**Project: IEEE P802.15 Working Group for Wireless Personal Area Networks
(WPANs)**

Submission Title: Dimming related CIDs in draft D1

Abstract: proposes comment resolutions for a set of CIDs related to dimming

Addition of new data mode #4

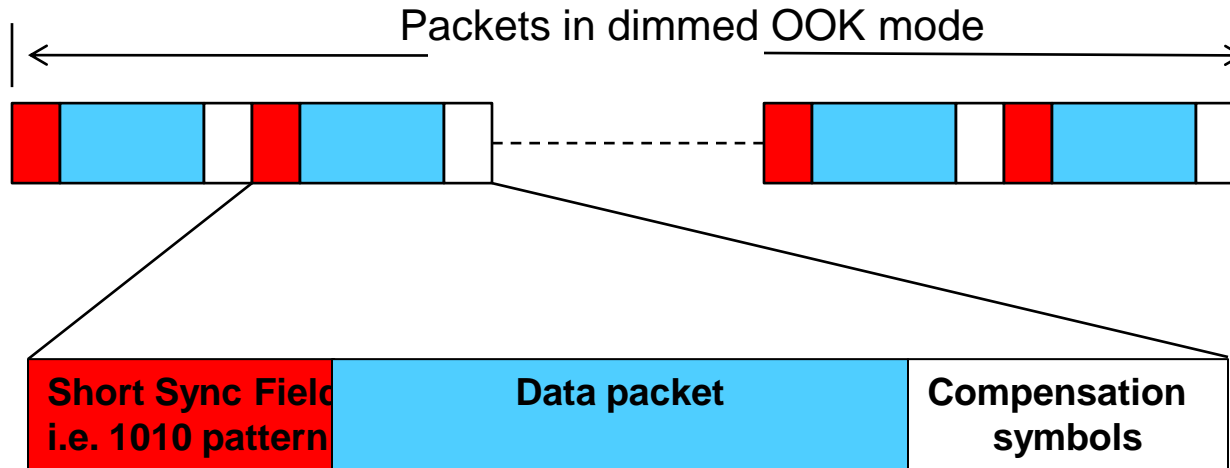
Dimmed OOK mode – CID 296, 751

Currently there are 3 data modes (single, packed and burst). It is suggested that a fourth data mode needs to be added called something like "Dimmed OOK Mode" with a packet structure like that shown on slide 4 of document 10/159r1. The exact text is TBD and will be submitted by mid-April 2010. This suggested text will include all the PPDU format changes to support this additional mode.

In a companion contribution, Intel will present a required additional data transmission mode to support OOK intra-frame dimming by inserting compensation time. The format of this frame will look similar to that of the existing burst mode.

We suggest the following 3-byte addition to the dimming notification command

Dimmed OOK mode fields	bits	Explanation on use
Number of packets in this mode	10	Number of packets (0 to 1023)
Length of Short Sync Field	4	0 to 15 clocks
Number of compensation clocks	10	i.e. number of clocks that the LED is turned OFF (0 to 1023)

Add a bit in the PHY header to indicate 'dimmed OOK mode'

- Packet is not a regular packet but is part of a "dimmed OOK packet burst"
- On receiving this packet, use the parameters stored in the receiver as obtained from the dimming notification command to know start of next packet
- Use one of the reserved bits for this purpose
